RIVERDALE CITY PLANNING COMMISSION AGENDA
CIVIC CENTER - 4600 S. WEBER RIVER DR.
TUESDAY – AUGUST 8, 2023

1.
 - a. Consideration of approval for and recommendation to City Council for Ken Garff Riverdale Amended Small Subdivision request, located at approximately 950 West Riverdale Road, Riverdale, Utah 84405, as requested by Kimley Horn and the Ken Garff Automotive Group.
 - b. Consideration of approval for Ken Garff Honda Preliminary Site Plan request, located at approximately 950 West Riverdale Road, Riverdale, Utah 84405, as requested by Kimley Horn and the Ken Garff Automotive Group.

Amended Subdivision and Preliminary Site Plan Review – Ken Garff Honda, 950 West Riverdale Road

Plan Review For Ken Garff Honda

SURVEY DATE: 4/23/23
 DRAWN BY: MGO
 JOB NO: 23-003
 SHEET: 1 of 1

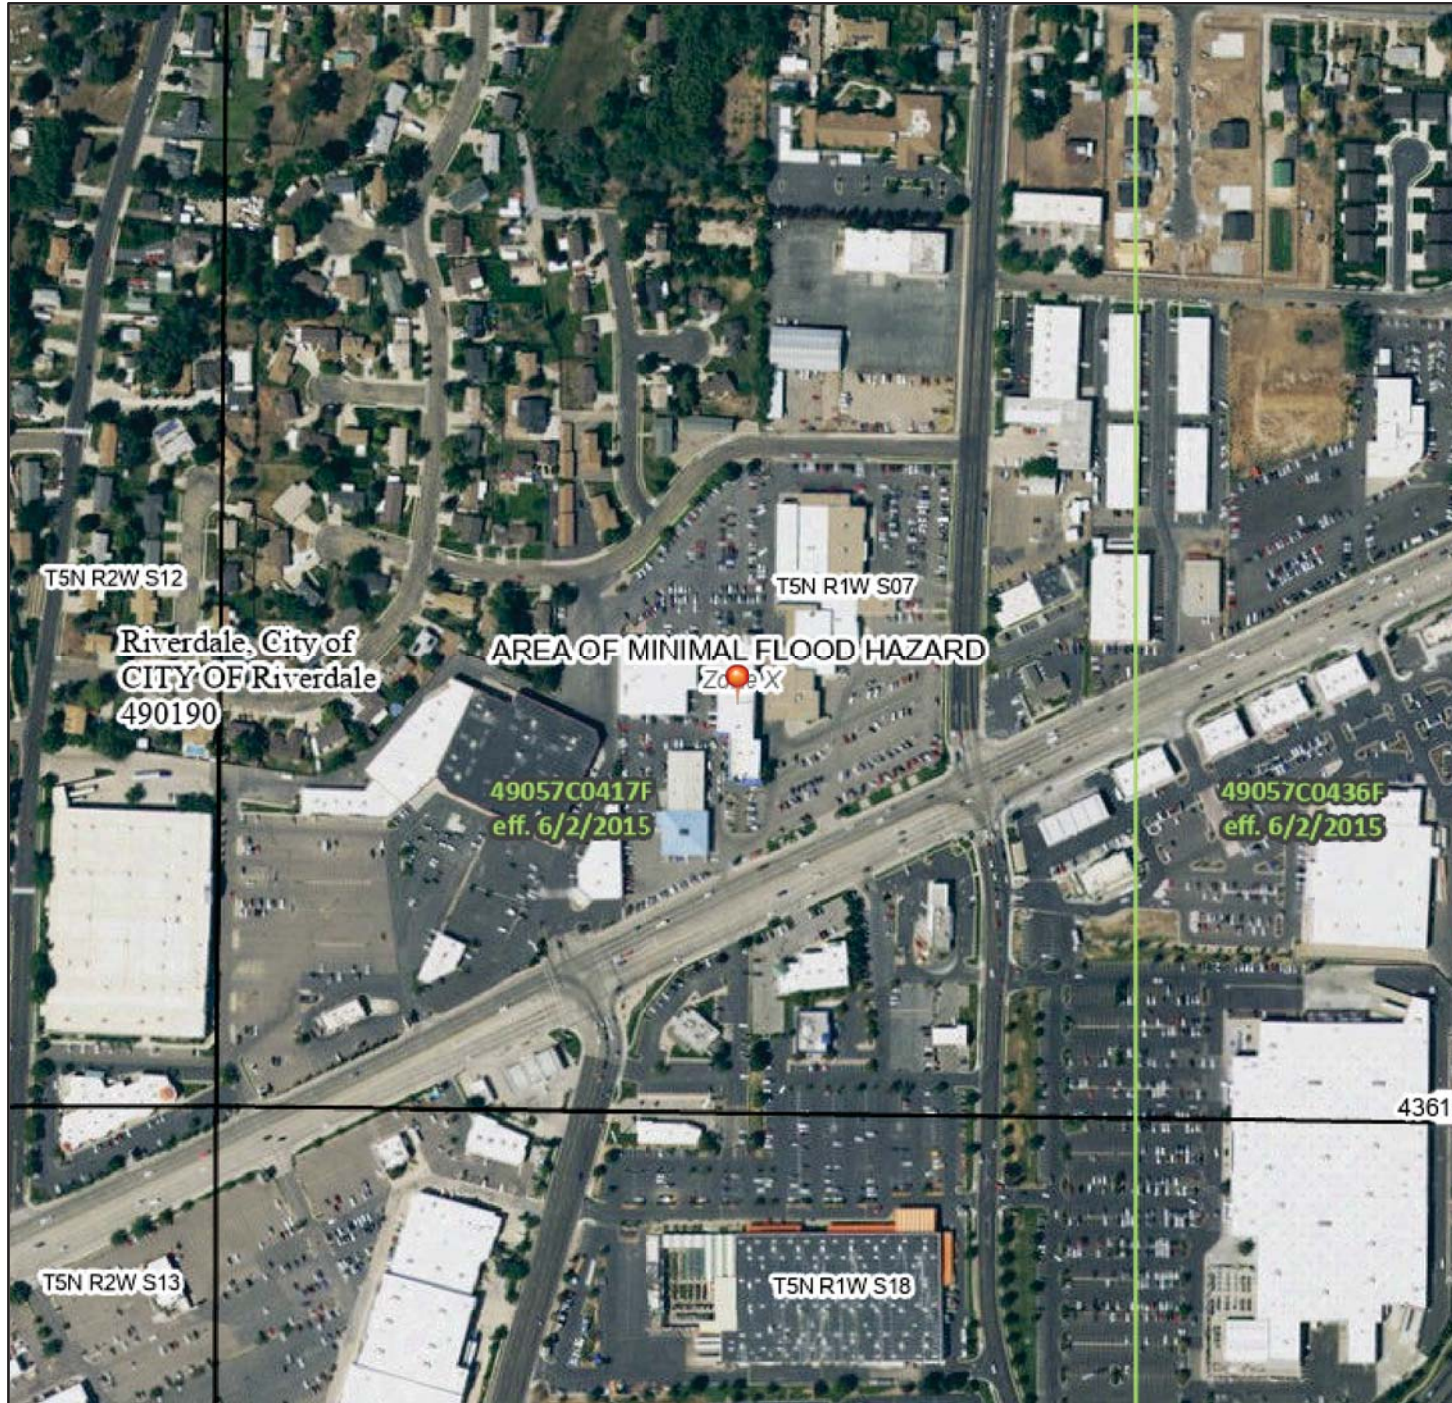
9. The Alta plat doesn't show the existing irrigation line traveling between the two buildings, it also doesn't show the existing storm drain line (SDCB is on Riverdale Road) that is partially getting removed?

SHEET
C1.00

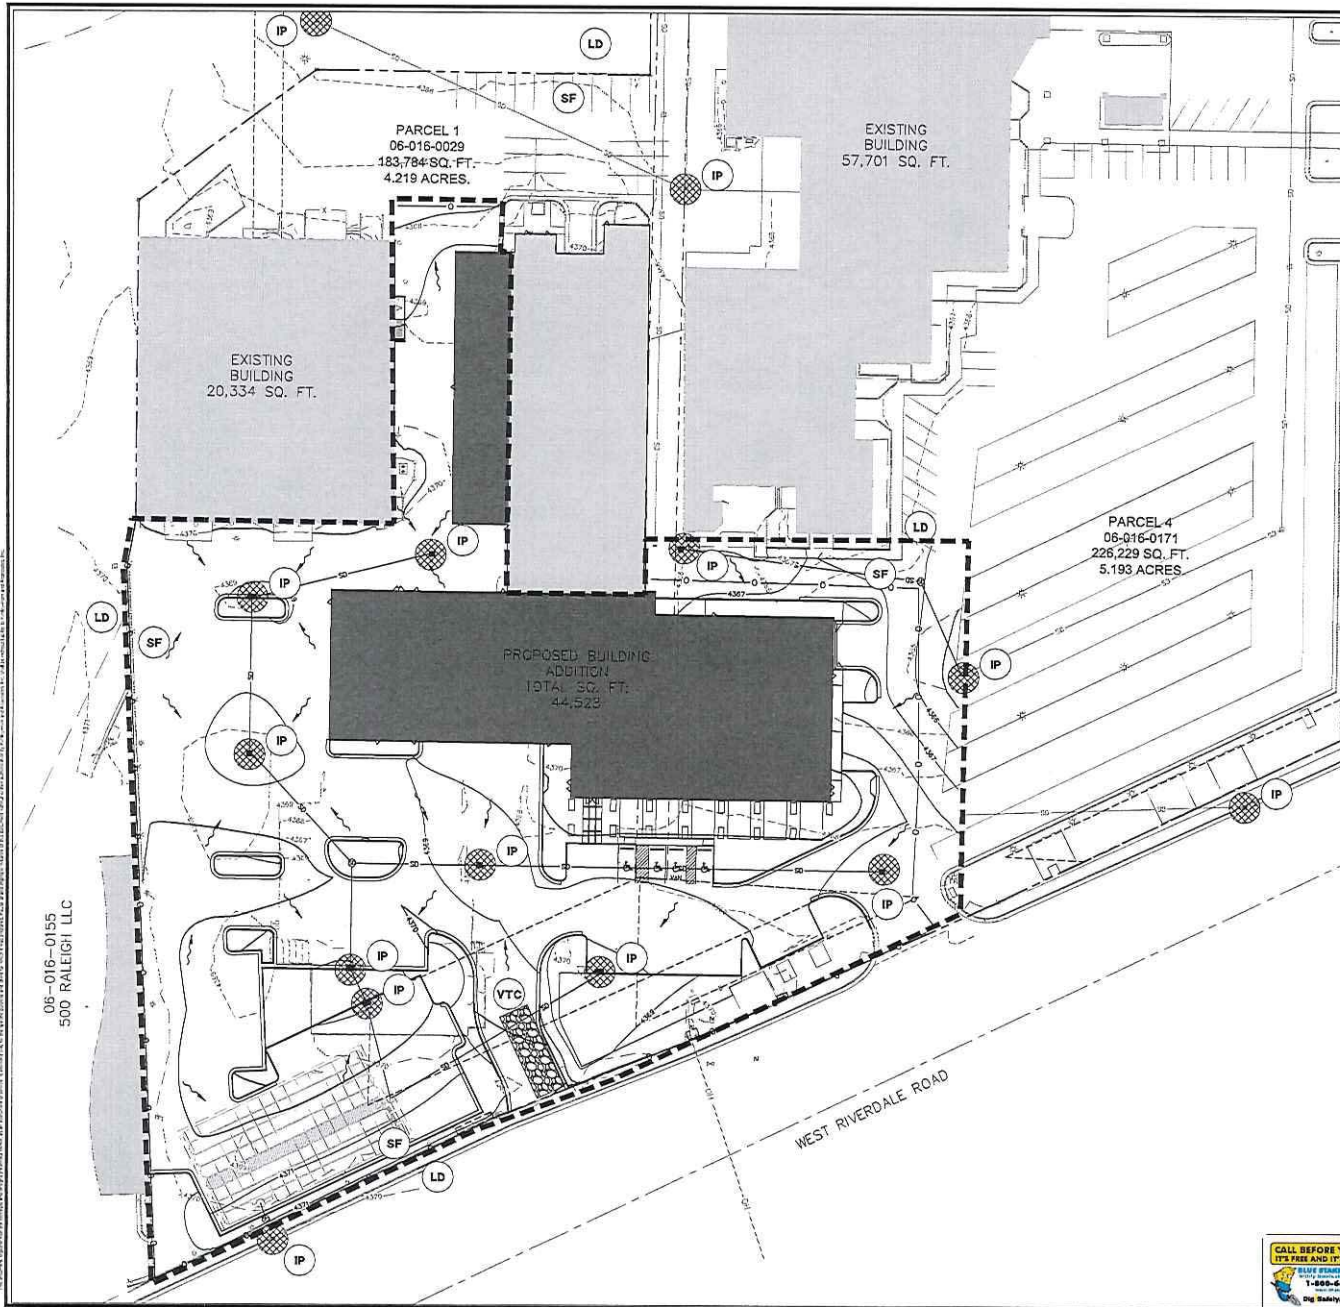
1. In the title, it shows Ogden and not Riverdale. (C1.00)
2. Need the UDOT Access agreement for construction. (C1.00)
3. Where is the proposed concrete washout area located?
4. Could the "not used" Detail 7 Box be removed? The lines are going through the Titleblock and 811 utility notes. (C1.20)
5. Add the State Road number at the end of Riverdale Road. i.e. SR-26 (C1.00)

SHEET
 L1.10

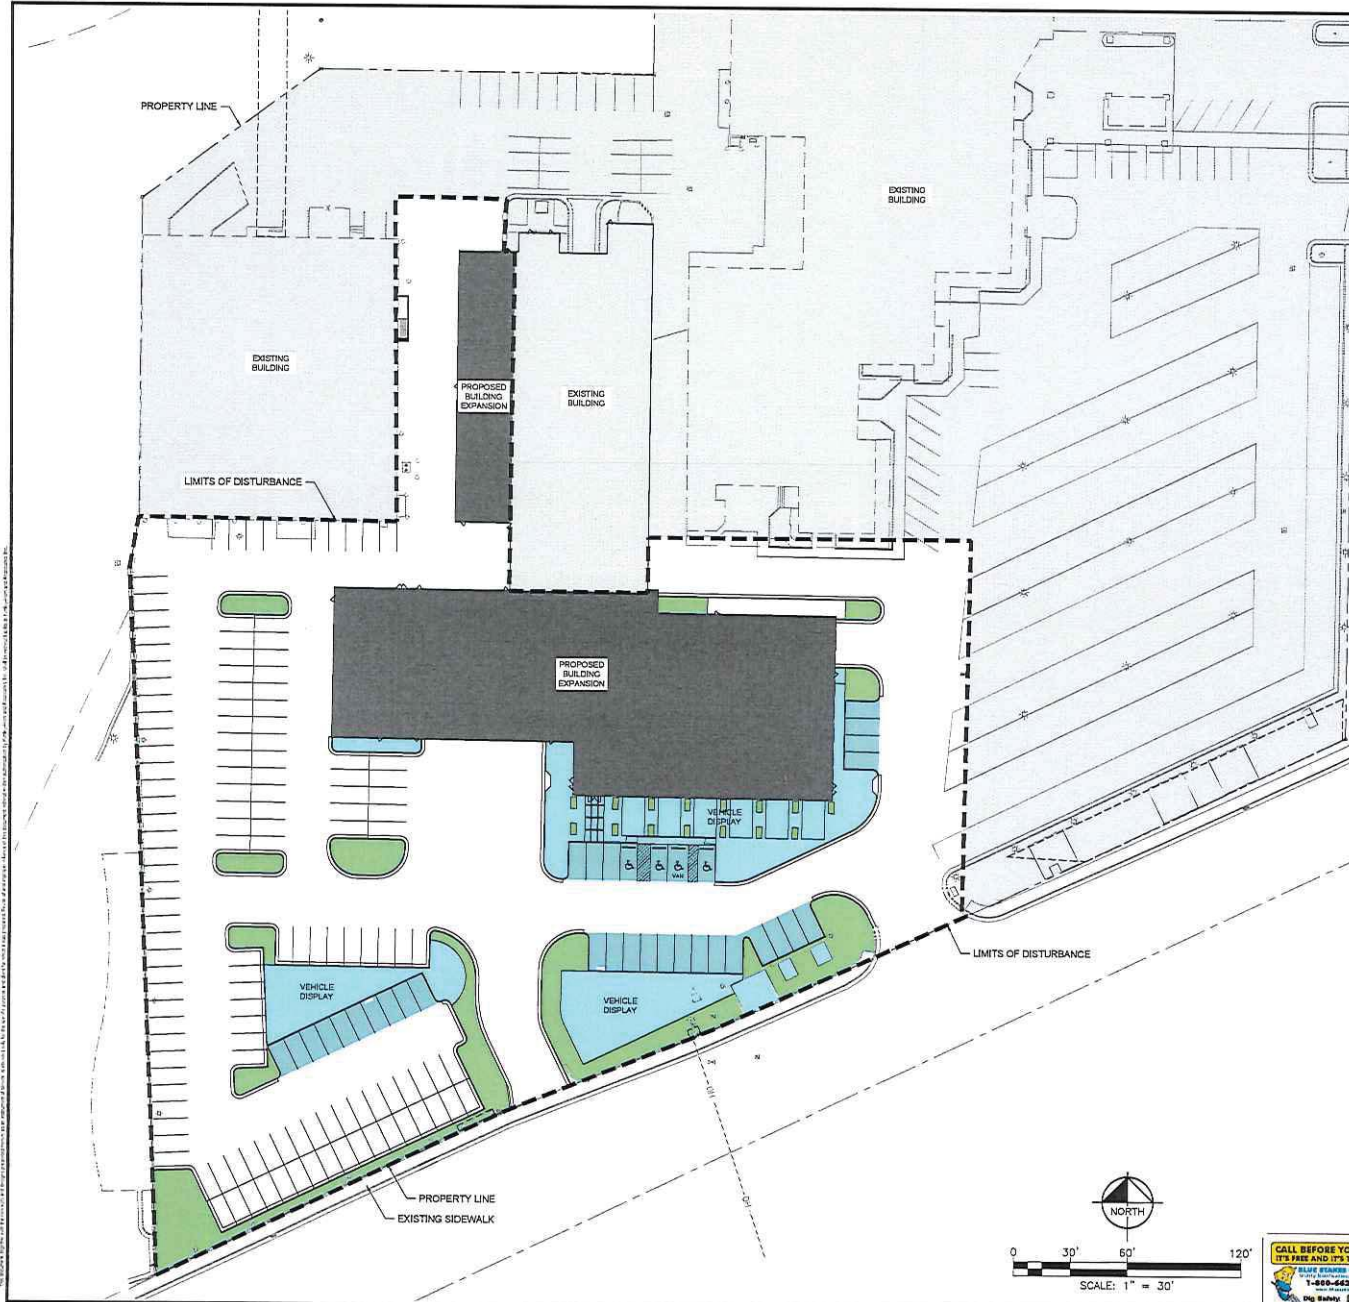
1. The landscaping/irrigation plan(s) are not complete. (L1.10)
